Land use impacts the environmental benefits of wind energy farms in China

This file contains all editorial decision letters in order by version, followed by all author rebuttals in order by version.

Your manuscript titled "Accounting for Land-Use Change Is Critical to Avoid Overstating the Climate Benefits of Wind Energy" has now been seen by 3 reviewers, whose comments are appended below. You will see that they find your work of some potential interest. However, they have raised quite substantial concerns that must be addressed. In light of these comments, we cannot accept the manuscript for publication, but would be interested in considering a revised version that fully addresses these serious concerns.

Fig S2 The spatial distribution of China's 393 wind farms and their land cover types.

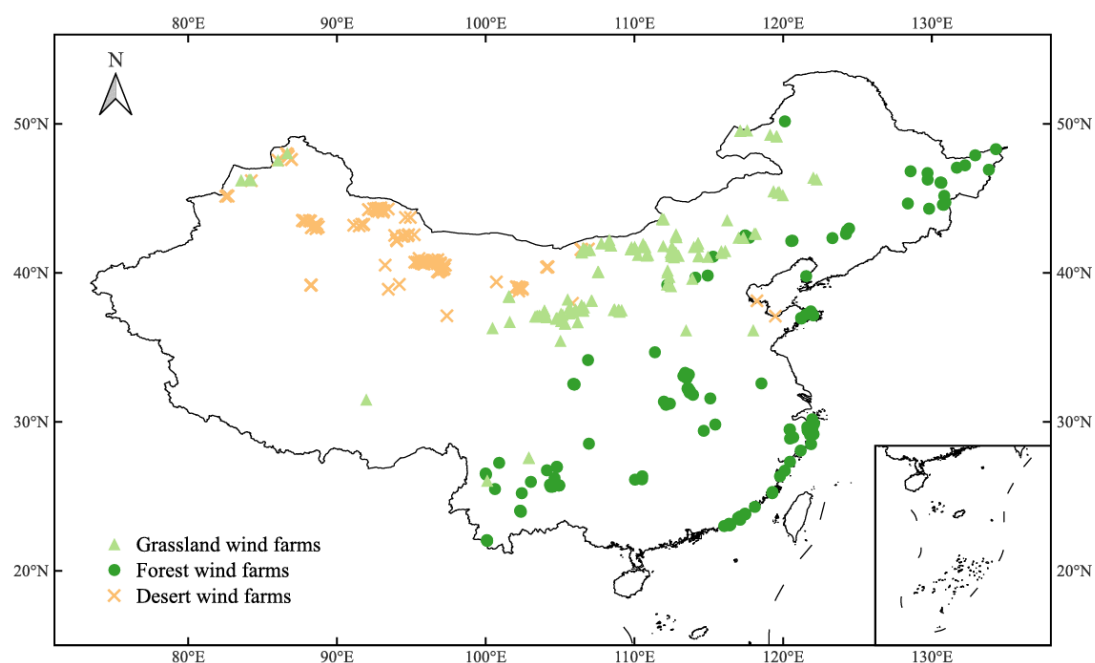
The methods applied by the authors appear to be robust in applying the LCA framework and gathering data from three specific locations (Fig. 7) and LUC-land cover change from the Century model. But how can the results remain robust for wind capacity for electricity generation in other locations? What is the expected variability in wind capacity together with LUC-GHG effects for other extreme locations suitable for wind power? The authors should address this point in their sensitivity analysis.

[Response] We sincerely appreciate the reviewer's thoughtful and positive feedback on our manuscript and the insightful suggestion. To address the concern regarding potential uncertainty of life-cycle GHG intensity and energy performance due to variations in wind potential for electricity generation across different locations, we conducted a comprehensive sensitivity analysis in the revision. We expanded our study to consider the variation in wind capacity of China's onshore wind farms across different regions. Specifically, we first identified all China's wind farms located in forests, grasslands and deserts from the harmonized global datasets of wind and solar farm database (Dunnett et al., 2020). A total of 128 forest wind farms, 141 grassland wind farms, and 124 desert wind farms were identified, covering a wide range of area across China (Fig. S2). Based on MERRA-2 wind speed data and power curves, we further calculated the capacity factor for the entire 20-year lifecycle of all these wind farms. The capacity factors calculated from these geographically representative wind farms were used as inputs in the LCA model to quantify the uncertainty ranges for the three selected wind farms. To assess the uncertainty of other factors including material consumption, life time, land-use area, transport distance and curtailment rate, $\pm 20\%$ changes in key factors and assumptions combined with Monte Carlo simulation were applied to the LCA modelling. The description of the methods was added in the Methods section (Page 24, Line 494-508), and the results were illustrated in Fig. 4 and presented in the Results section (Page 11, Line 178-193). It can be seen from Fig. 4 that

the results for our selected three wind farms (one from each of forest, grassland, and desert) fall within the interquartile range of the sensitivity analysis outcomes, indicating that our chosen sites are representative of the broader range observed across China's wind farms. Therefore, we concluded that while there may be variability in wind capacity and associated LUC-GHG effects among different locations, our case studies capture the essential characteristics and provide a reliable basis for understanding these impacts. The selected wind farms could be considered representative for understanding the wind capacity for electricity generation and associated LUC-GHG effects in other locations across China.

Fig. S2 The whole image of (a) forest wind farm, (b) grassland wind farm, and (c) desert wind farm from Google Earth Pro (version 7.3.6.10201).

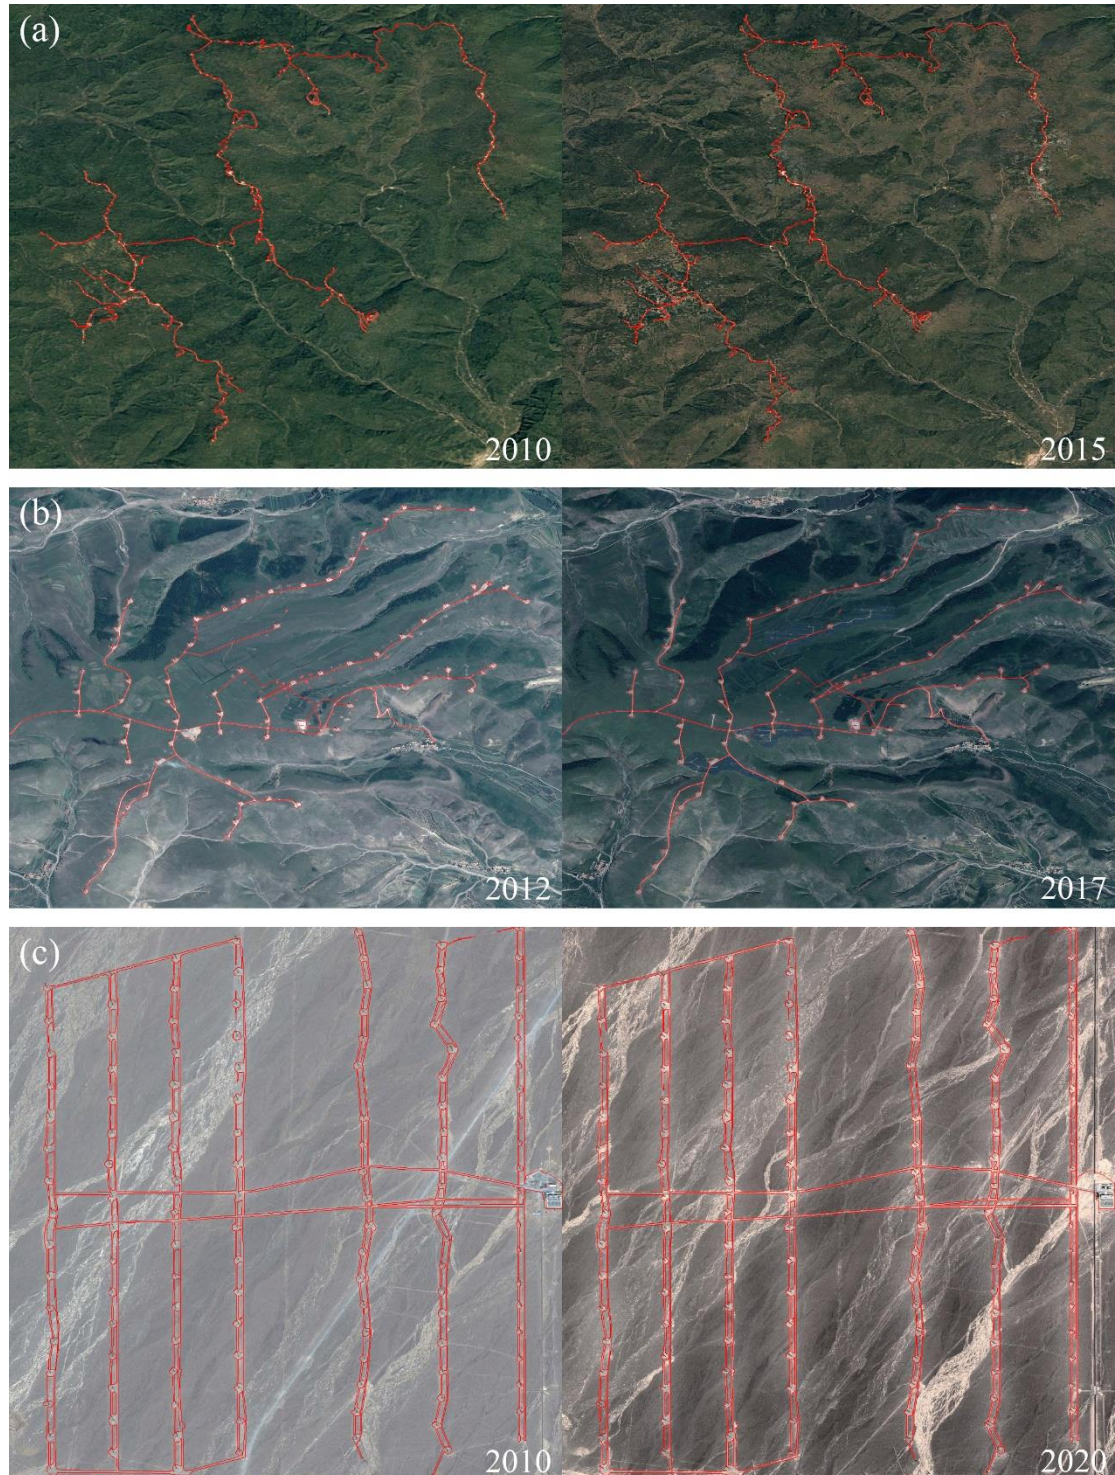
The authors did not quantify the original land use during the construction of wind power projects, and the quantification procedure is not consistent among the three wind farms. It looks like the authors have recognized the partial reclaim process of the cable area between turbines (Figure 7c). However, the authors only included part of them (i.e., for typical turbines). The authors have not clarified why they addressed these differently. Additionally, the land use data is also not consistent. In Figure 7c, part of the cable areas is annotated, whereas no corresponding areas have been annotated for Figure 7a and Figure 7b. Also, there are no images showing the whole picture of the wind farms. So it is hard to determine if a long access road is needed. Recent studies on wind in the US show that wind farms may require a long access road when they are located in a remote area. So, it is reasonable to guess that in China similar situation happens, especially in the forest case.

(1) In this study, we indeed conducted detailed quantifications of all permanent land occupation areas including the roads, foundation clearing areas, cable areas. The quantification procedure was the same in the three wind farms. To avoid any potential ambiguity, we have revised the relevant descriptions in the MS (Page 18. Line 387-389), and included complete remote sensing images of the three wind farms in the SI files (Fig. S2) to provide more intuitive data support.

(3) We agree that the long access road will pose a significant impact on final result. For the three studied wind farms, there is truly a long road for forest wind farm (Fig. S2a).

This road was included in the quantifications and considerations of land use impacts in our study. We now provided the complete images of the wind farms in the SI files (Fig. S2).

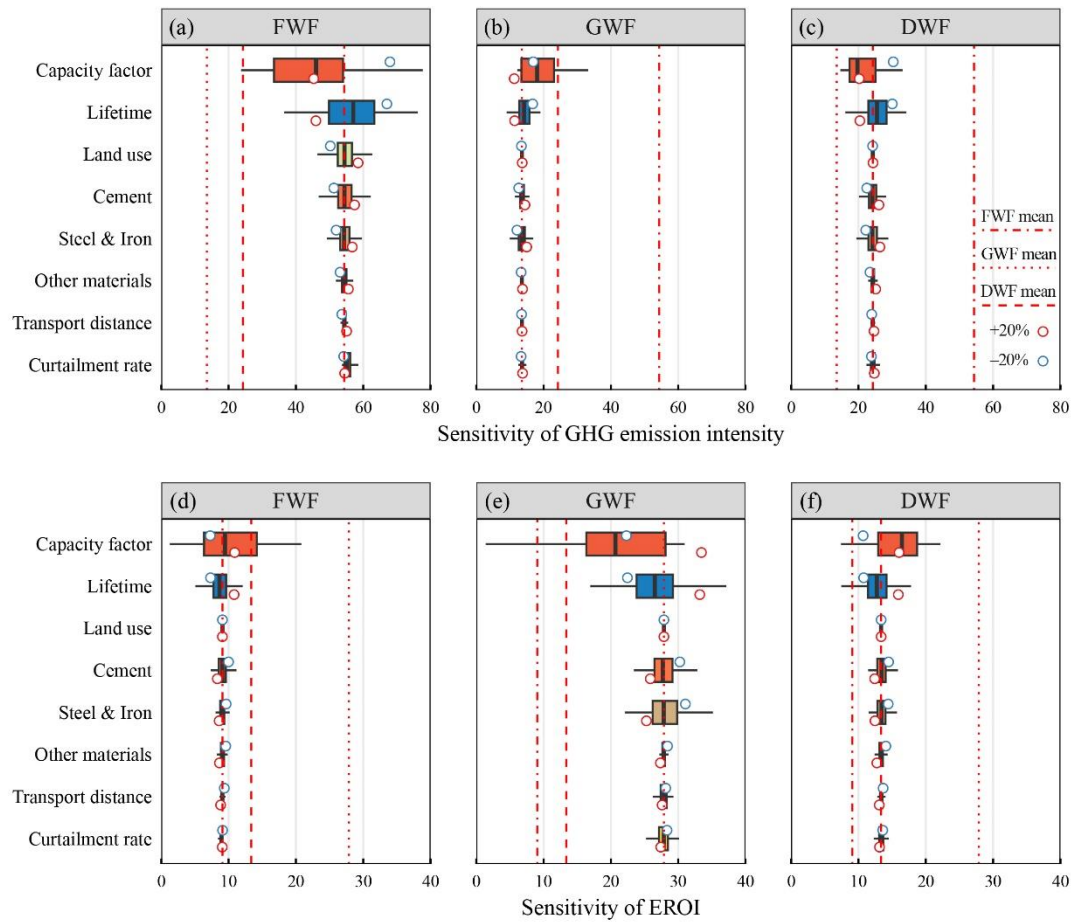
Uncertainty analysis. Please provide a list of uncertainty sources in the entire analysis.

[Response] We provided the detailed information of uncertainty sources and the analysis process in the Methods section (Page 23, Line 490-508) and in SI files (Page 9, Line 234-254). We conducted Monte Carlo sensitivity analysis in key factors and assumptions including the consumption of different materials, capacity factor, life time, land-use area and transport distance and curtailment rate based on previous research and datasets. We included the new results from the Monte Carlo sensitivity analysis in the revised Fig. 4. This figure not only illustrates the impact of uncertainty on the key

outputs but also prove that the selected wind farms are representative of the broader trends observed across China's wind farms.

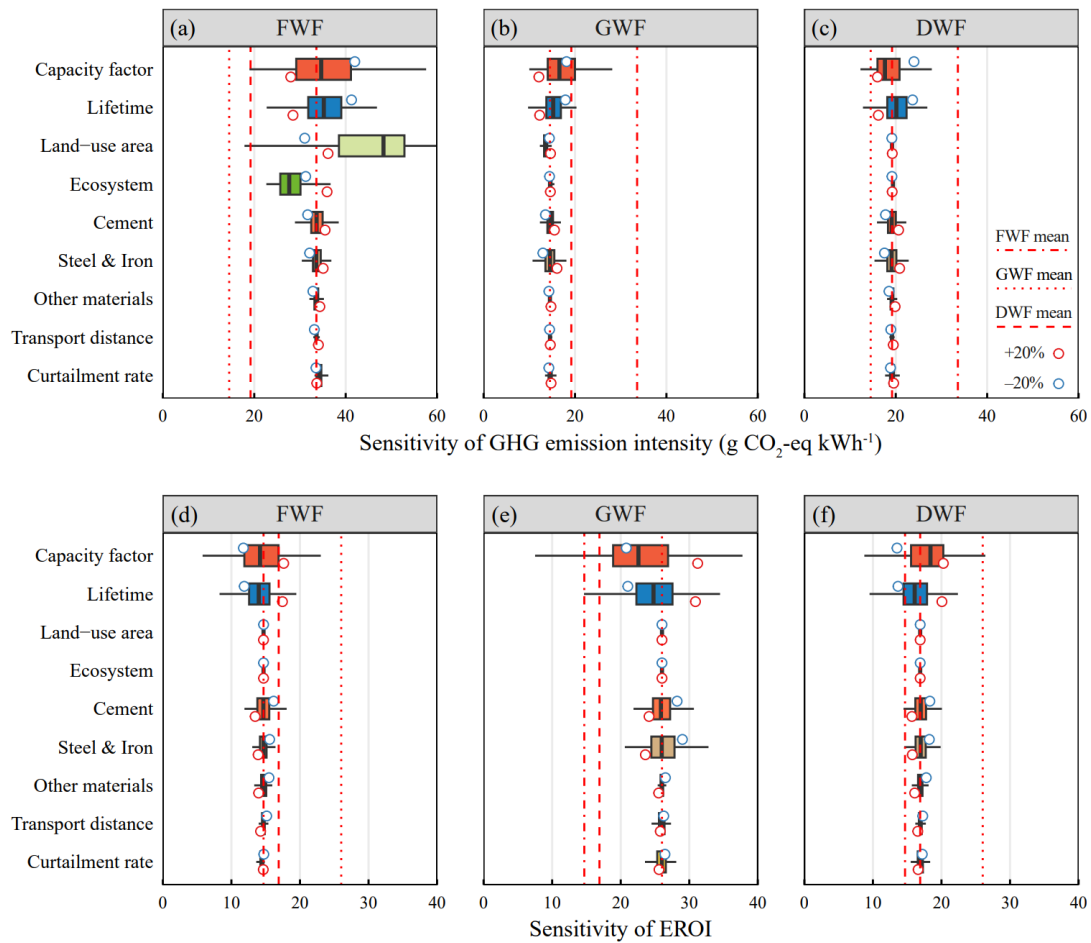
However, it is unclear if you have used the global wind atlas bias correction when estimating wind power output for the 183 geographical locations, which were used in the sensitivity analysis. Please clarify in methods. If you did not do so, bias-correction has to be included. If you did use bias-correction and capacity factor variation is still high, please discuss the limitations of your approach in the discussion section. Even with bias-correction, estimating wind power output from global climate data may introduce significant bias - this can be stressed in the discussion. This applies in particular to cases where capacity factors are below any economic viability.

[Response] Thanks for your suggestions. Following your suggestions, we replaced the single-source MERRA-2 data with complementary reanalysis products (MERRA-2 and ERA5-Land) to enhance robustness. We further conducted bias-correction for these two reanalysis data using the version 2 of the global wind atlas (GWA v2). We first calculated the ratio between GWA v2's long-term wind speed values (V_{GWA2}) and 20-

Site	Original CF	Corrected CF	Change
FWF	0.2079	0.3453	+66%
GWF	0.4190	0.4015	-4%
DWF	0.2658	0.3451	+30%

The revised CF of FWF now aligns with typical operational thresholds, resolving your concern about the plausibility in the original value. All the subsequent calculations in emission intensity were updated using these validated generation metrics. Further sensitivity analyses of capacity factor were conducted utilizing the corrected CFs, with full distributions now visualized in Fig. 4. This comprehensive approach not only mitigates MERRA-2's inherent biases but also substantially strengthens the spatial representativeness of our generation estimates through GWA v2's enhanced resolution.

Fig. S5 Power generation across three land-use types for 493 wind farms in China.

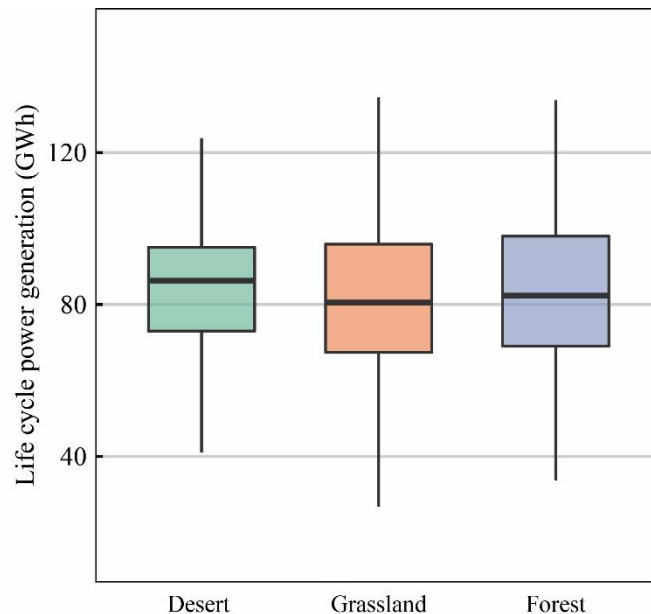
Furthermore, it would be great to see a boxplot that compares generation of turbines per land-use types for all sampled locations.

[Response] Following your valuable suggestions, we have added a boxplot figure (Fig. S5) in Supplementary Information. comparing power generation across land-use types

for all 493 wind farms (standardized to 1.5MW turbine). This result reveals insignificant differences in generation capacity between forest, grassland, and desert sites ($p > 0.05$), reinforcing that emission variations across different sites stem primarily from land-use impacts rather than wind resource.
